Re: Amended Plans – State Significant Development Application SSD-55844212

Property: 39 Dehli Road, North Ryde (Lot 21 / DP 1003588)

I refer to the above-mentioned State Significant Development Application – Trinit Lighthouse Build-to-Rent exhibited on 28 September 2023 for:

Source: Macquarie Park TOD Rezoning

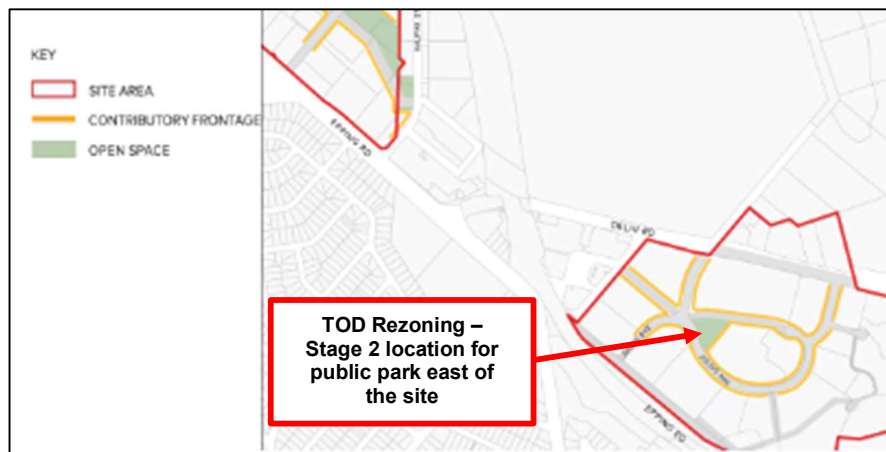
- **Invalid structure plan – access connections:** The Urban Design Guidelines for the Stage 2 Rezoning depict a number of infrastructure and through-site links through the subject site with no clear indication as to how these connections are to be provided. The amended proposal, subject of the current Development Application, fails to provide adequate connectivity and public domain links envisioned by the rezoning, as detailed further within this objection.

Block-modelling of future envisioned built form central to 'Neighbourhood 7' precinct of the Macquarie TOD rezoning.

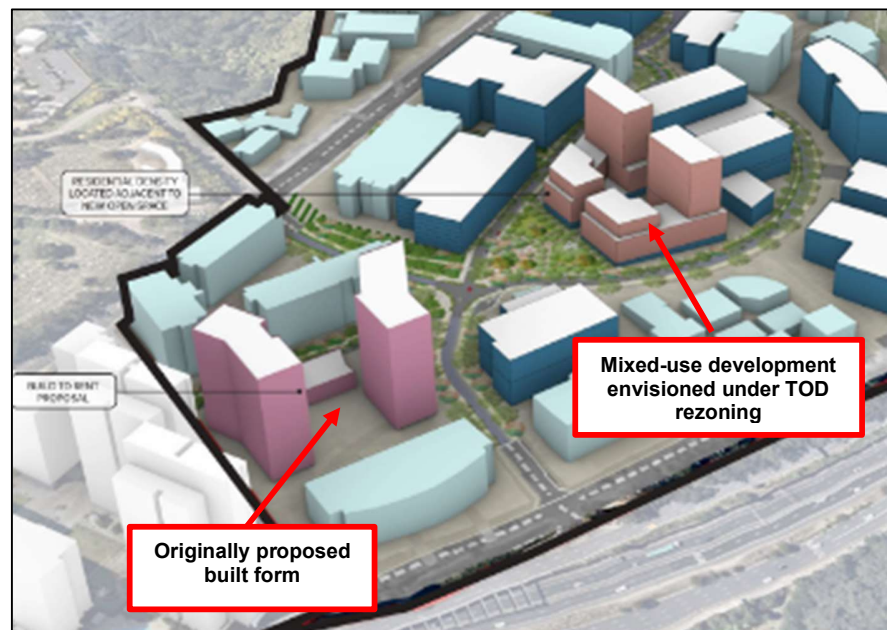
- **Additional tower density in the E3 Productivity Support Zone:** The TOD rezoning envisioned future residential – mixed use development in the surrounding precinct consistent in height with the subject development application as depicted below. The additional intensification of residential development in this neighbourhood has not been considered within the Environmental Impact Statement for the proposal, and would in future contribute to view loss, visual impact, and public infrastructure impacts raised within this submission and our original objection.

The modelled building massing for this future envisioned site presents a more articulate and responsive distribution of density in contrast to the subject application which maximises residential yield with little regard for its relationship to the public domain and broader urban context. The proposed development has failed to consider the cumulative impacts of further increased residential densities in the precinct in its insufficient provision of public open space and through-site access links on the subject site.

Amended public domain area (blue highlight) and internal communal area (pink highlight) proposed by the development Source: Architectural Plans

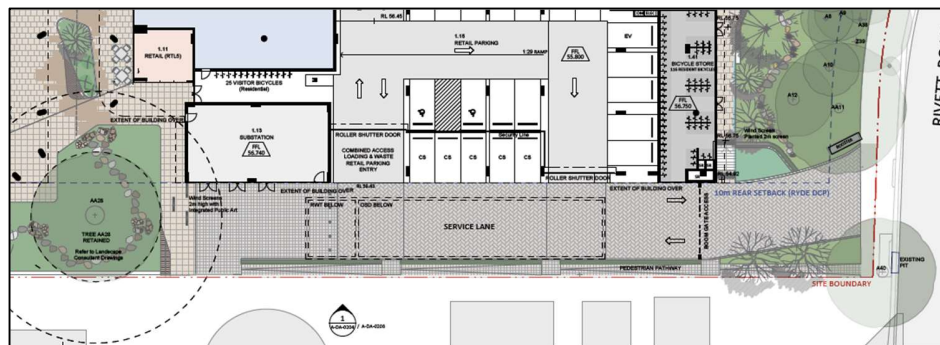
- The applicant's response to submissions document provides that an additional 2,507m² of 'public domain' area is provided by the amended development. Given the proposed minor reduction in building footprint it is considered that the amended plans provide only a token increase to communal area through the inclusion of narrow and unusable parts of the site along the south-western boundary, and has included the proposed 'shopping plaza' central to the site.

Further, the public domain area has included part of the New Link Road to be dedicated to Council under the proposed Macquarie TOD Stage 2 rezoning of the precinct, thereby erroneously attributing a future potential roadway to the development's contribution to public recreation area.

Further, the applicant has labelled internal areas within the development as 'communal areas' a part of the amended yield diagram documentation. It is unclear how this communal area is attributed to residents of the development or the public, noting these areas include bicycle storage facilities, staff and residential amenities, concierge and lobby areas for the development. The amended proposal has failed to satisfy the requirements of Clause 6.9(3)(a) and (b) in this regard and must not be provided with incentive FSR and height by the consent authority.
